ADDENDUM NO. 1

TO: PLANS AND SPECIFICATIONS FOR STATE OF MISSOURI

**Renovate Lobby and Restrooms 1st and 2nd Floor
Howerton State office Building
Jefferson City, Missouri
PROJECT NO.: O2339-01**

6 FIRST FLOOR - MEN'S LOBBY RESTROOM INT. ELEVATION
SCALE: 1/2" = 1'-0"

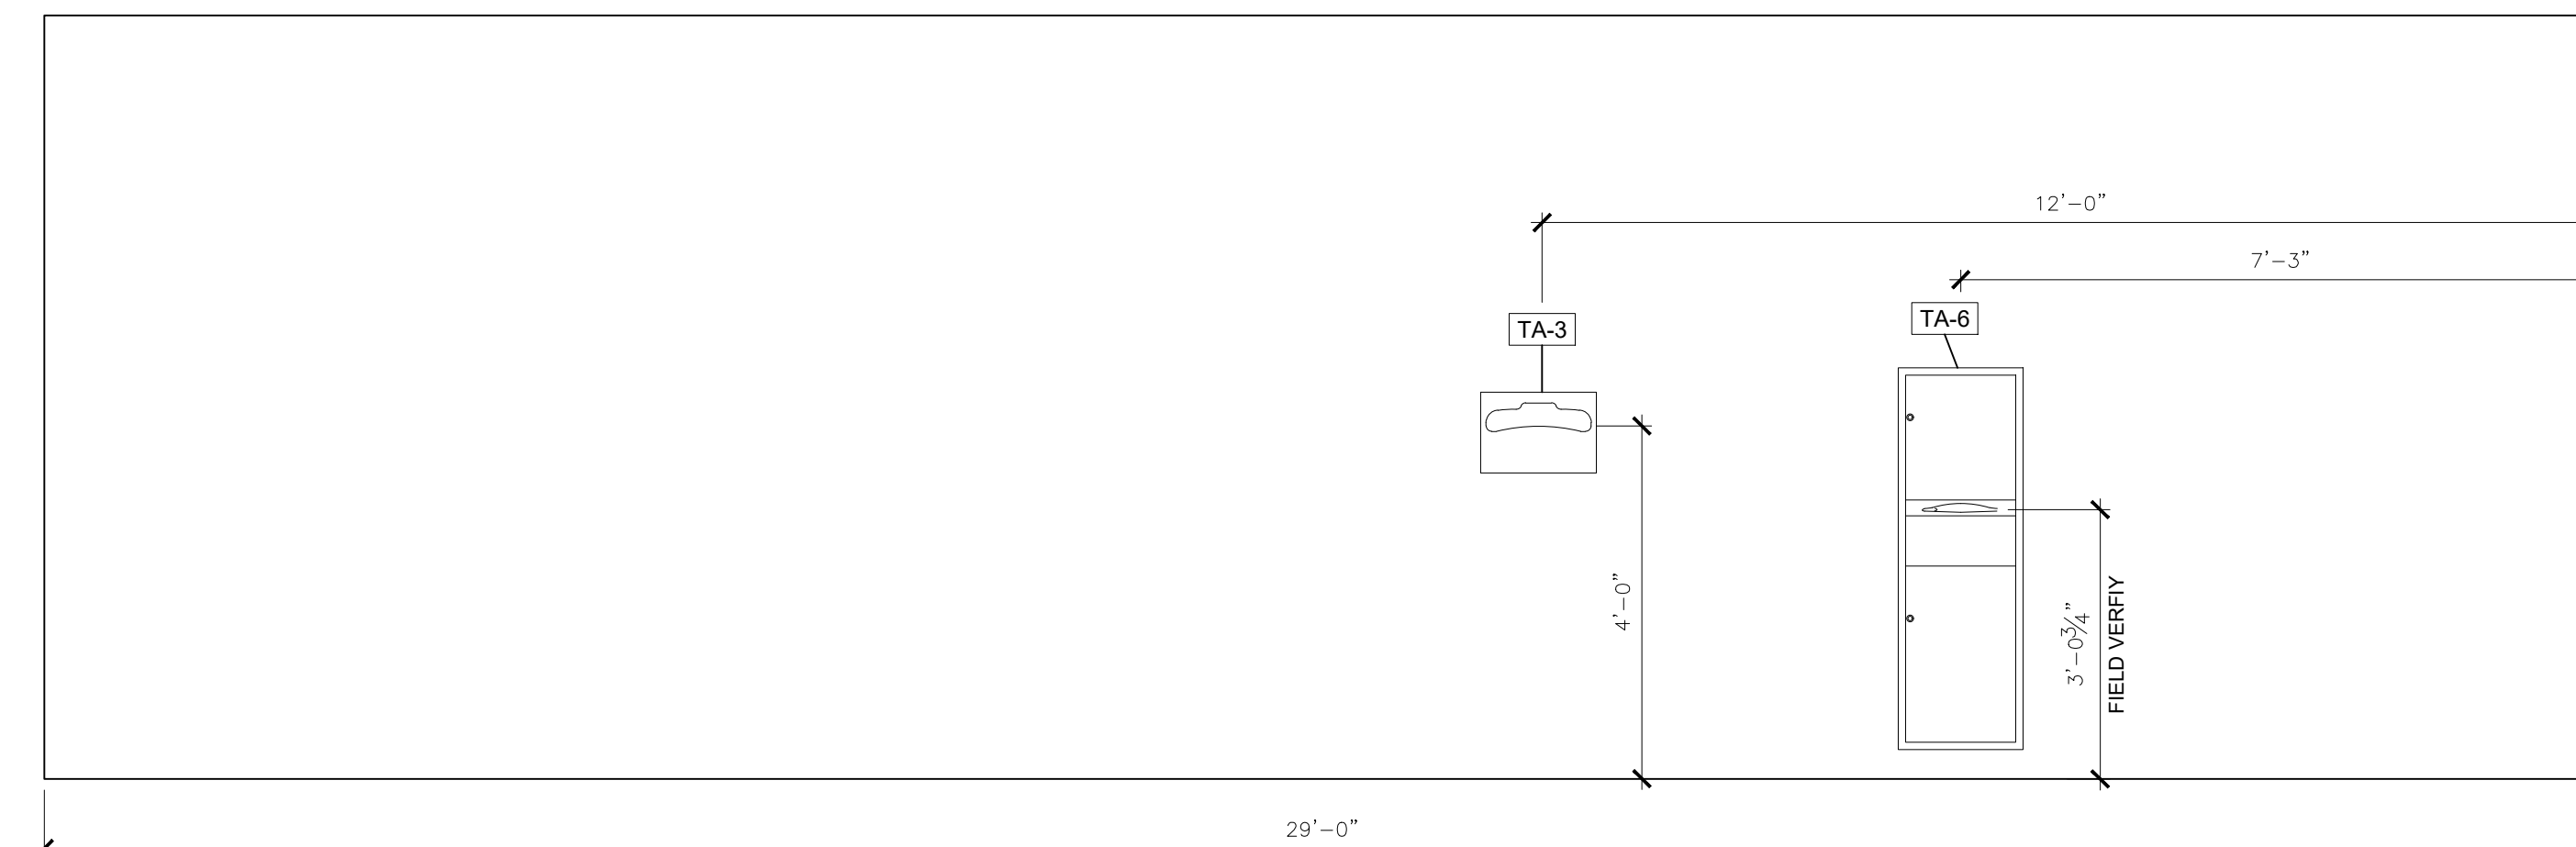
A-202

1. Restroom Finish Schedule: Clarifications per mark.
 - GB-1 Changed grab bar to 36" grab bar.
 - GB-2 Changed grab bar to 42" grab bar.
 - GB-3 Changed grab bar to 18" grab bar.

- TA-7 Changed coat hook to coat hooks (to be installed inside of stalls)
- TA-8 Changed mirror to 24" x 72" mirror.
- TA-9 Changed mirror to 24" x 36" mirror.
- 2. Changed note from: See A-601 for full fixture schedule to See sheets A-104 - A-105 for full fixture schedules.

A-203

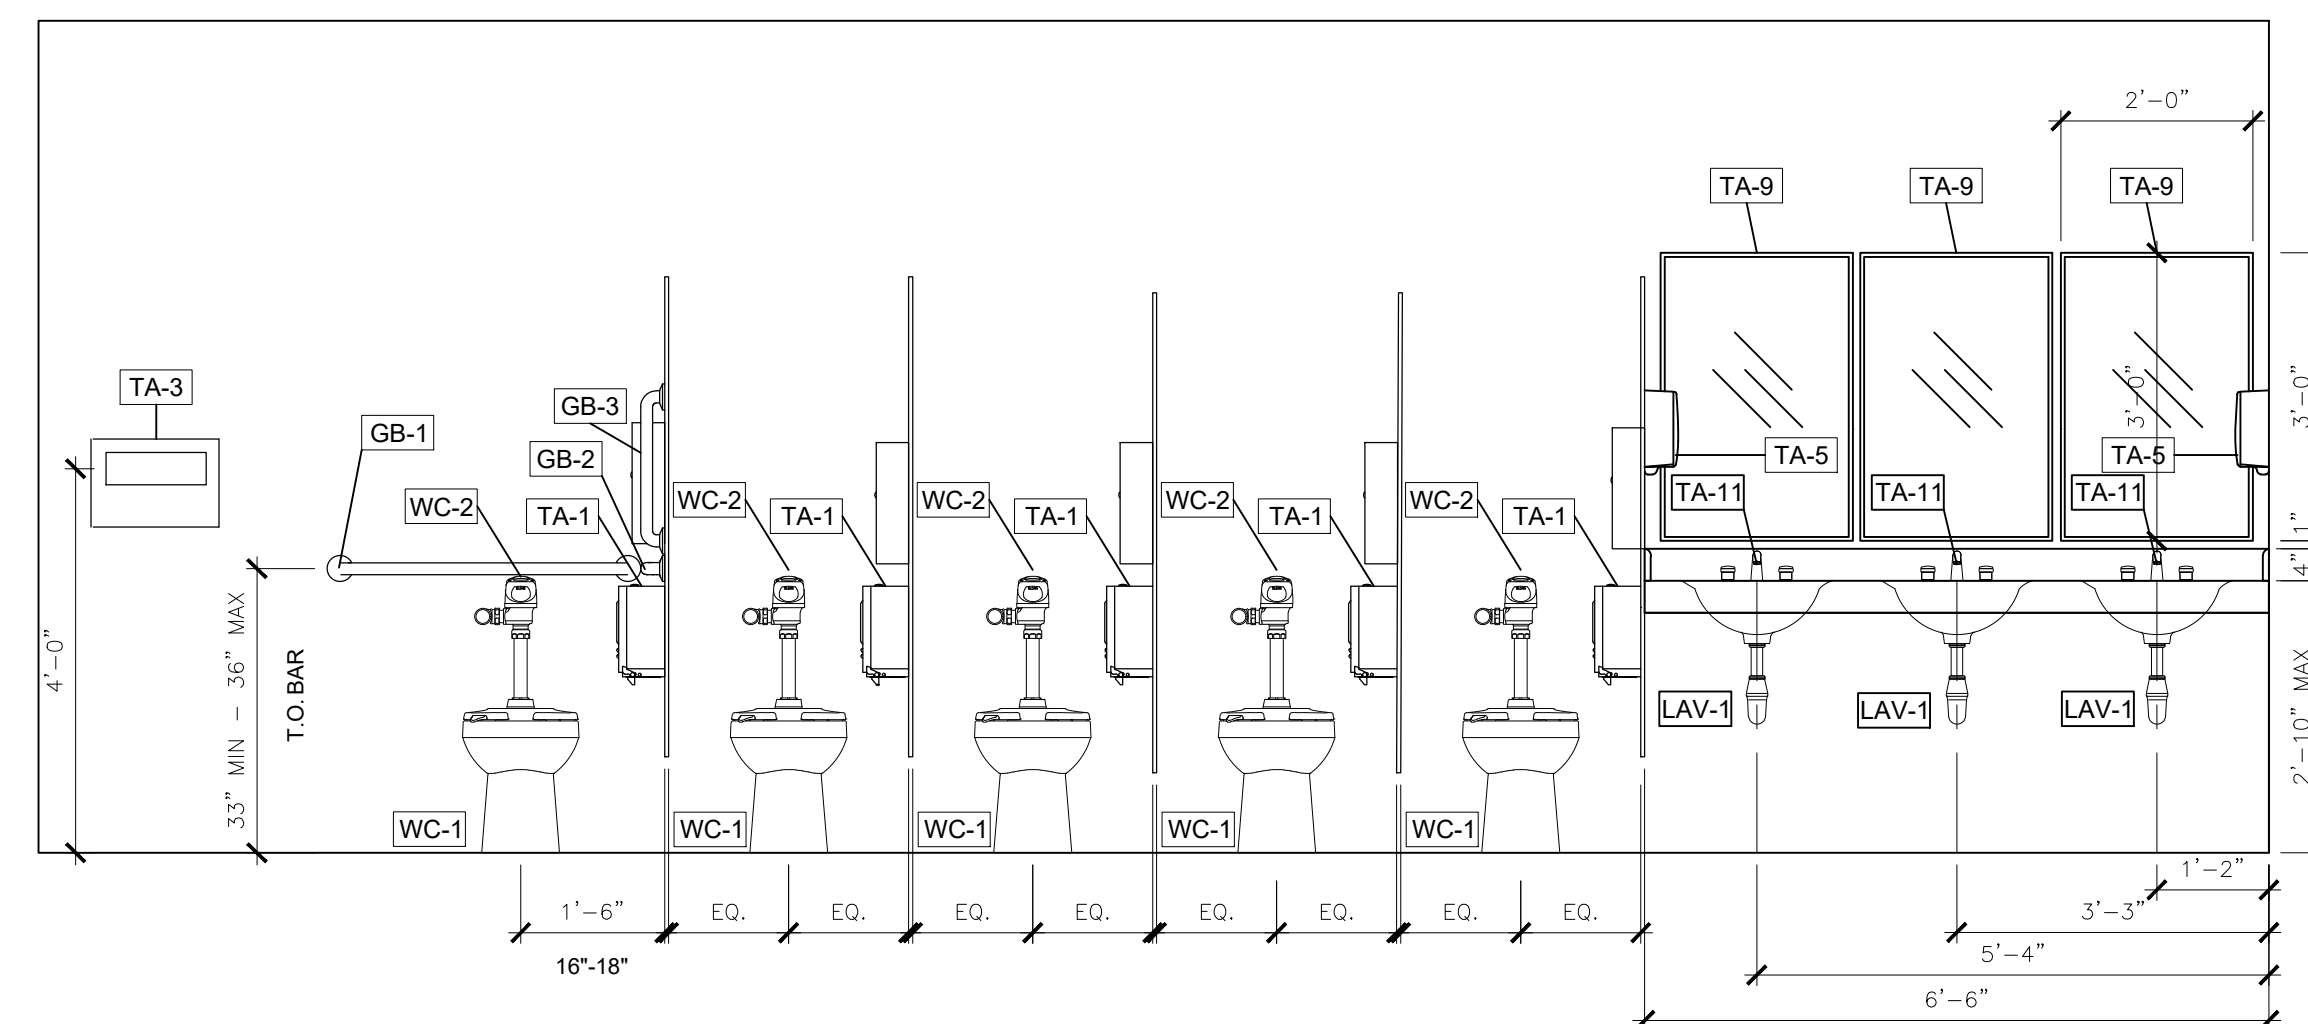
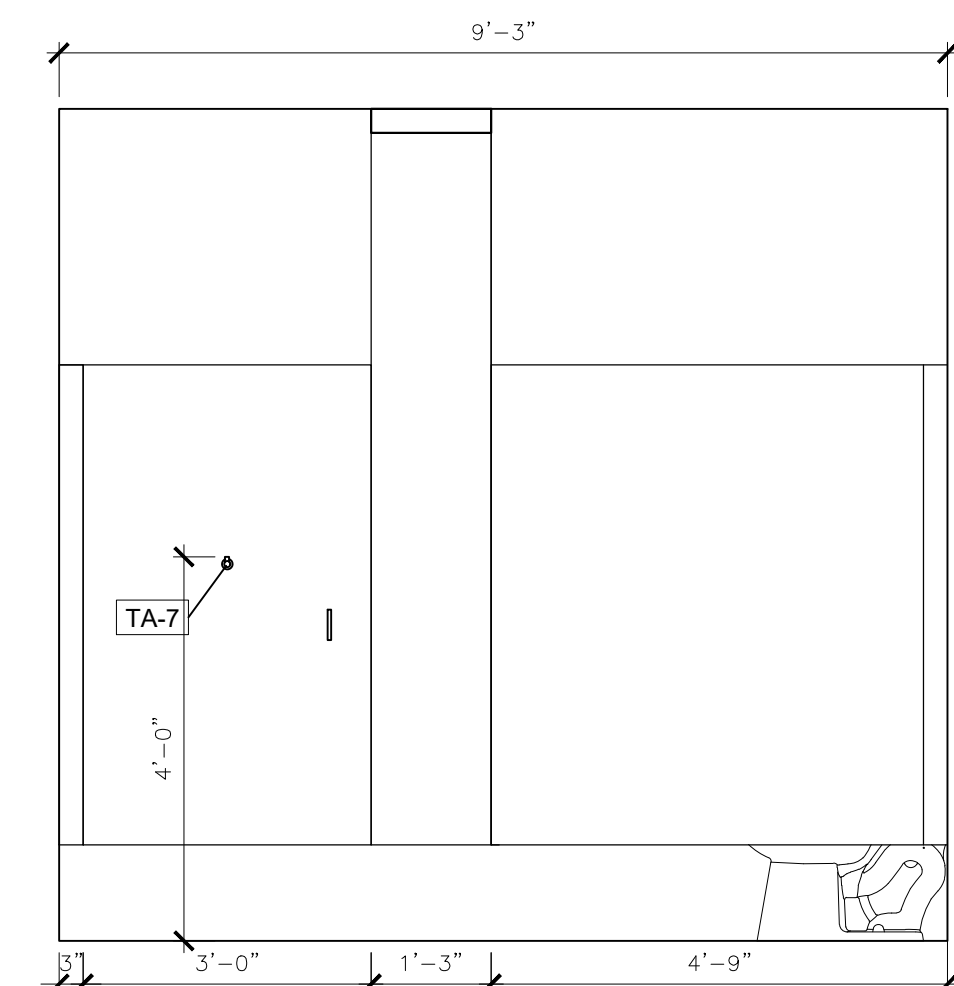
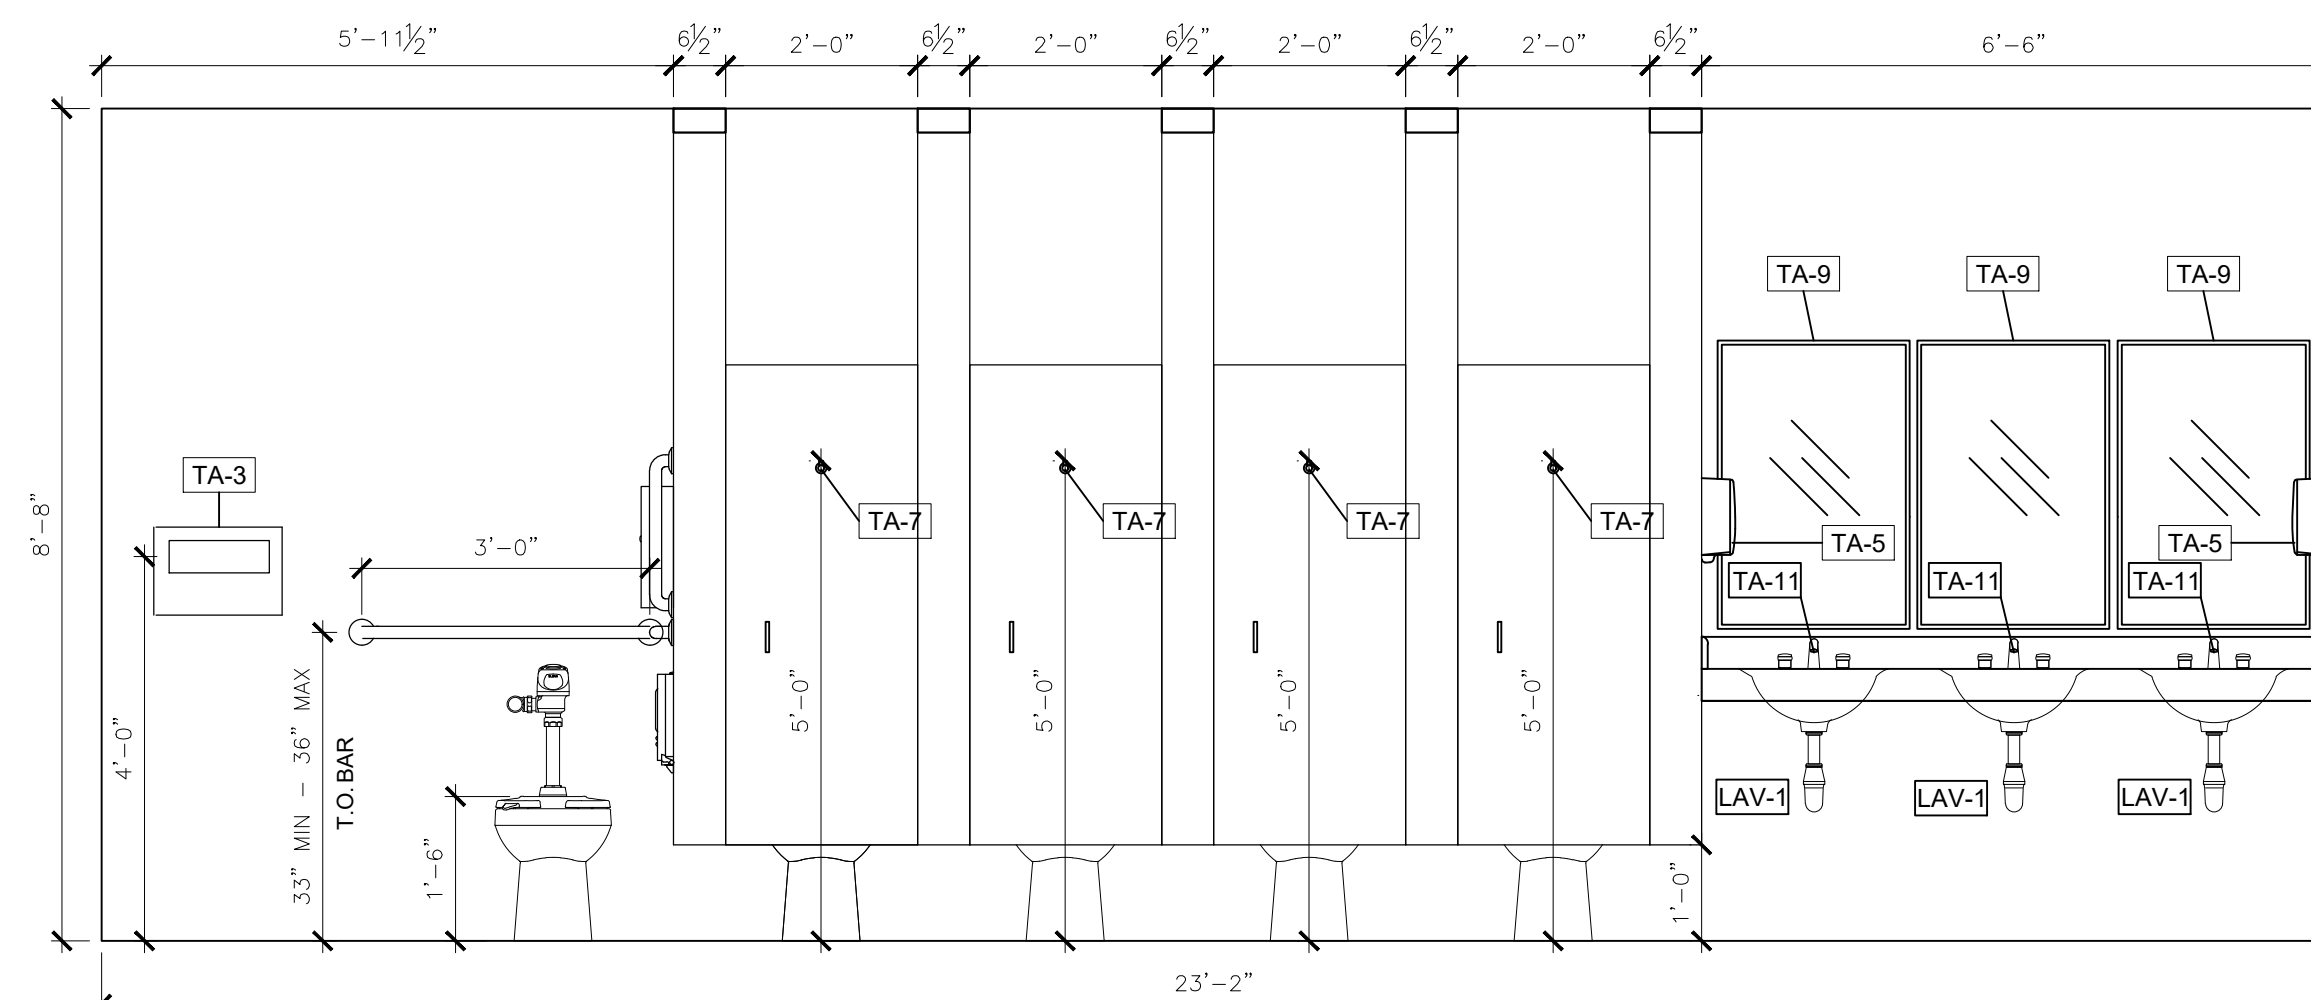
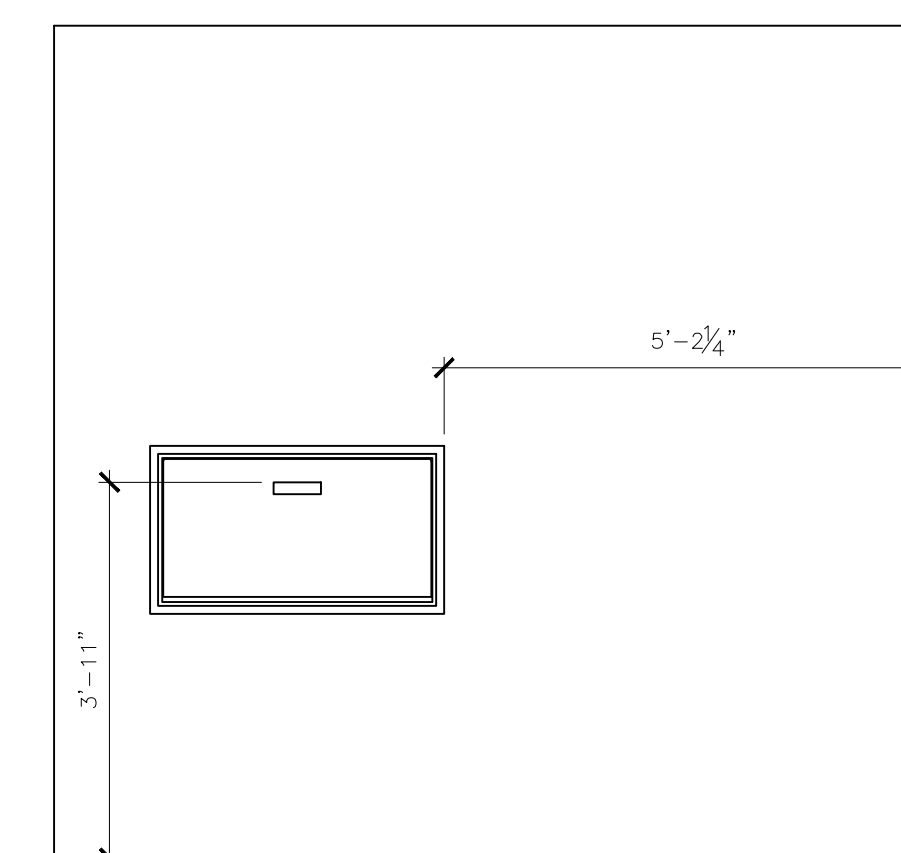
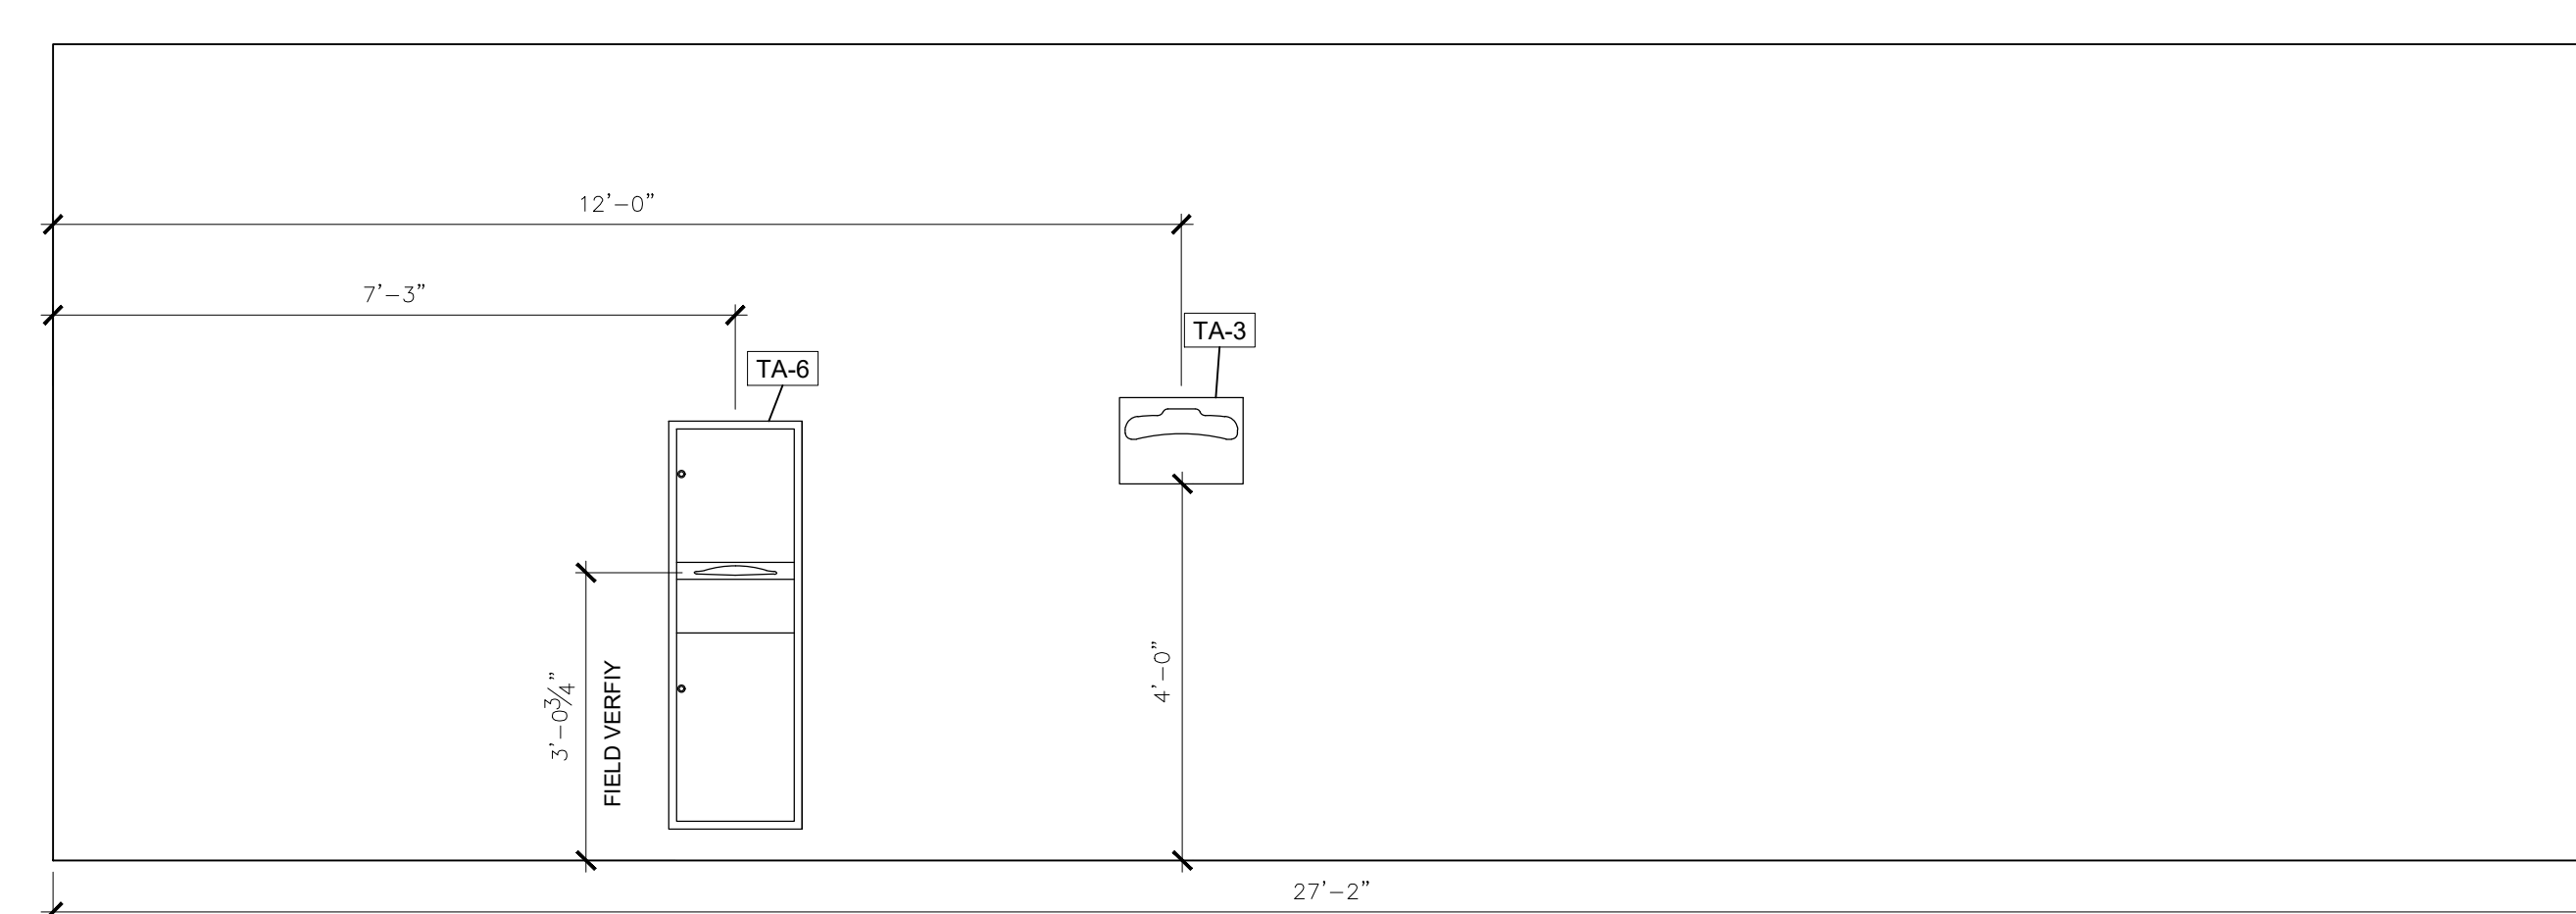
A-203

- 1. Restroom Finish Schedule: Clarifications per mark.
 - GB-1 Changed grab bar to 36" grab bar.
 - GB-2 Changed grab bar to 42" grab bar.
 - GB-3 Changed grab bar to 18" grab bar.
 - TA-7 Changed coat hook to coat hooks (to be installed inside of stalls)
 - TA-8 Changed mirror to 24" x 72" mirror.
 - TA-9 Changed mirror to 24" x 36" mirror.
- 2. Changed note from: See A-601 for full fixture schedule to See sheets A-104 - A-105 for full fixture schedules.
